# Access Compliance Report

## Public Rights-of-Way

### (Curb Ramps)

Intersection ID: 50584	Main Street: GREAT_LAUREL_RD	Cross Street: GRAND_FIR_RD	Location: SE
ADA ID: 73EE7C354C4E	Ramp Type: Perp	Initial Pass/Fail: Fail	Overall Compliance: No
Severity Score: 12.5			
Codes/Mitigation Info/Possible Solution		Field Measurements/Component Compliance

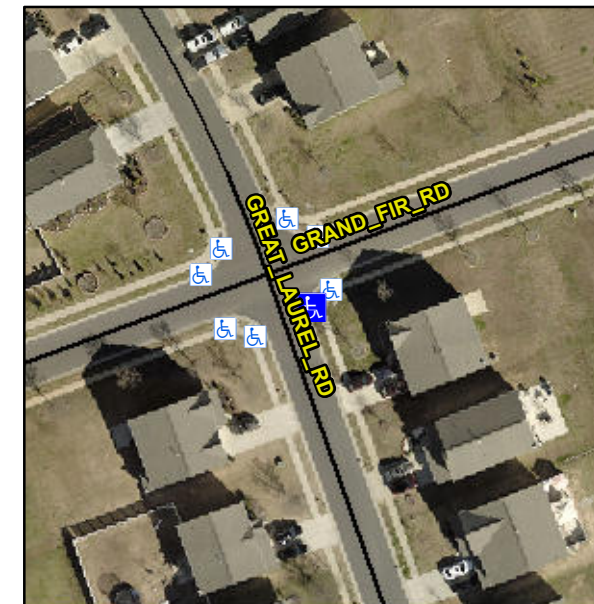
**Not Found, R304.2.2**

Compliance	Description	Data	Compliance	Description	Data
N/A	Ramp Length (in)	48.5	No	Ramp Slope (%)	9.1
Yes	Ramp Width (in)	48.0	Yes	Ramp XSlope (%)	0.0
N/A	Flare Type LT	N/A	N/A	Flare Type RT	N/A
N/A	Flare Slope LT (%)	N/A	N/A	Flare Slope RT (%)	N/A
N/A	Flare Traversable LT?	N/A	N/A	Flare Traversable RT?	N/A
N/A	Landing Length (in)	N/A	N/A	DWS Provided?	N/A
N/A	Landing Width (in)	N/A	N/A	DWS Contrast?	N/A
N/A	Landing Slope (%)	N/A	N/A	DWS Length (in)	N/A
N/A	Landing X Slope (%)	N/A	N/A	DWS Full Width?	N/A
N/A	Landing Curb? (Y/N)	N/A	N/A	DWS Offset (in)	N/A
N/A	Shared Landing?	N/A			
N/A	Gutter Ponding?	N/A	N/A	Gutter Slope (%)	N/A
N/A	Gutter Lip Ht (in)	N/A	N/A	Gutter X Slope (%)	N/A
N/A	Painted X Walk1?	No	N/A	Painted X Walk2?	N/A
	X Walk 1 Direction	To W		X Walk 2 Direction	N/A
N/A	X Walk 1 Width (in)	N/A	N/A	X Walk 2 Width (in)	N/A
	X Walk 1 Slope (%)	0.6		X Walk 2 Slope (%)	N/A
	X Walk 1 X Slope (%)	1.9		X Walk 2 X Slope (%)	N/A

**Remove & Replace Entire Ramp.**
